| VILLAGES AT STERLING RANCH | | | |
| EARLY GRADING AND EROSION CONTROL PLAN OFF-SITE DISTURBANCE AREA | | | |
| DRAWN BY | MAW | (H) 1" = 100' | SHEET 6 OF 9 |

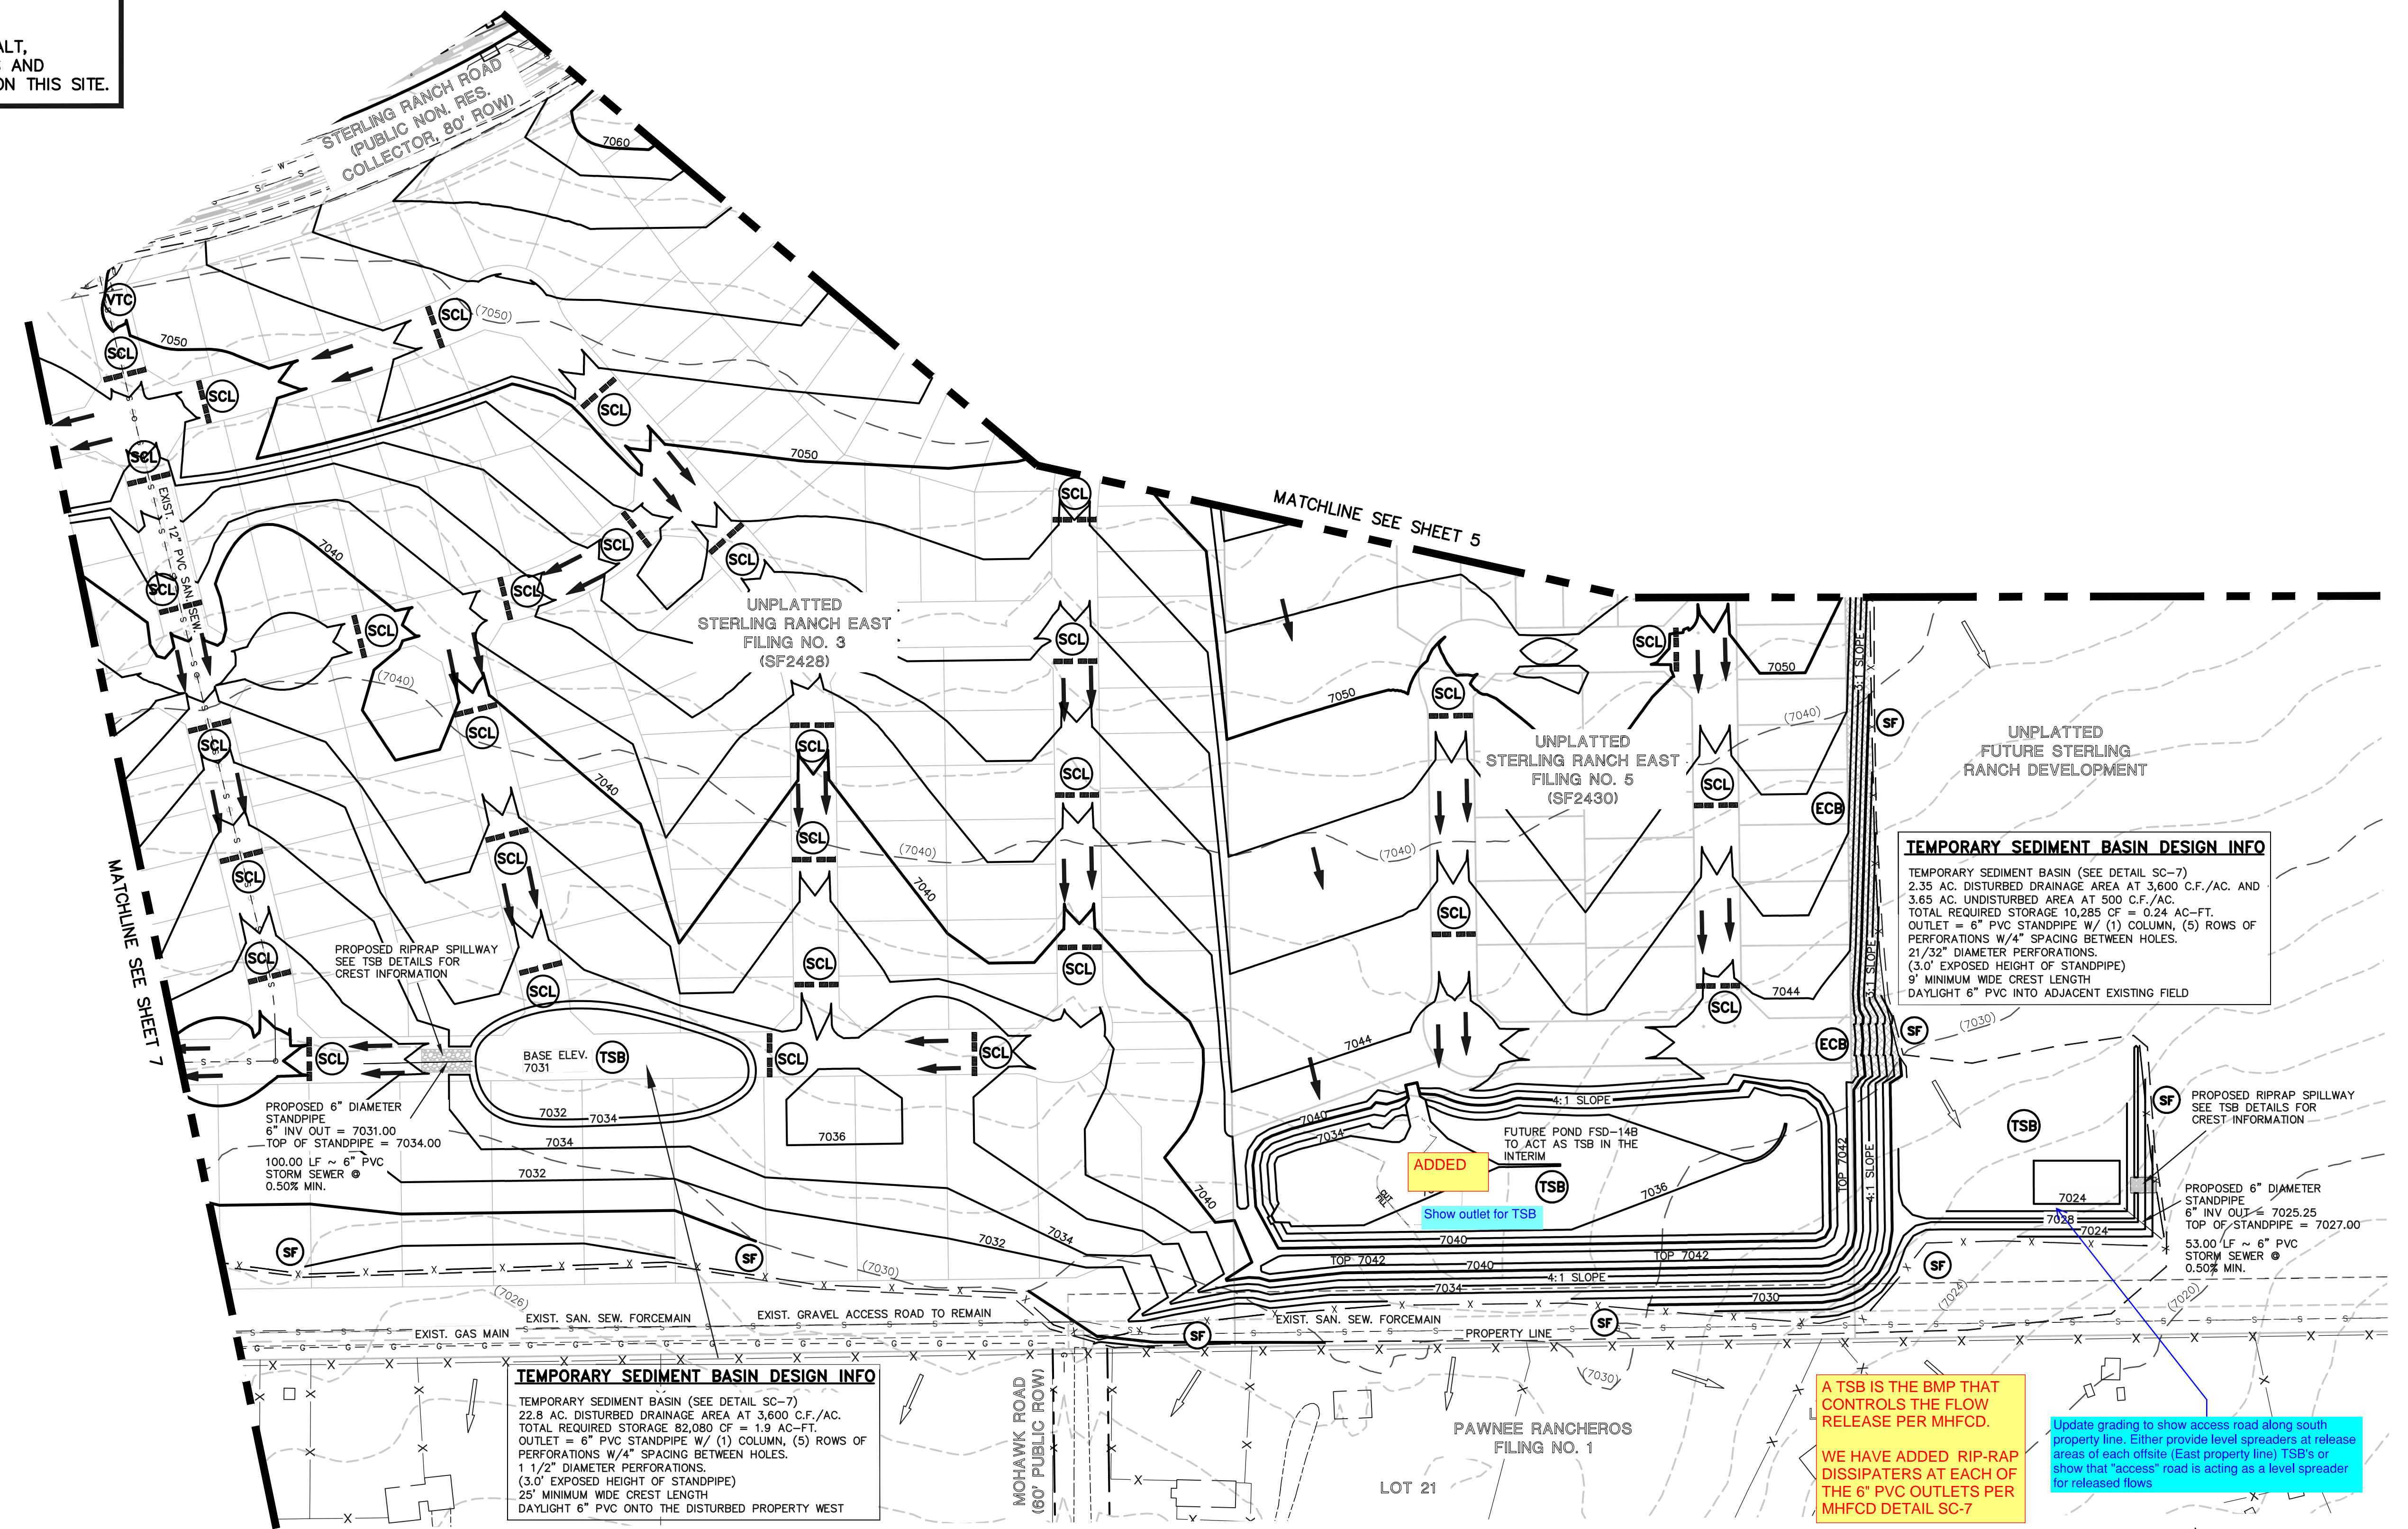
Update grading to show access road along south property line. Either provide level spreaders at release areas of each offsite (East property line) TSB's or show that "access" road is acting as a level spreader for released flows

A TSB IS THE BMP THAT CONTROLS THE FLOW RELEASE PER MHFCD.
WE HAVE ADDED RIP-RAP DISSIPATORS AT EACH OF THE 6" PVC OUTLETS PER MHFCD DETAIL SC-7
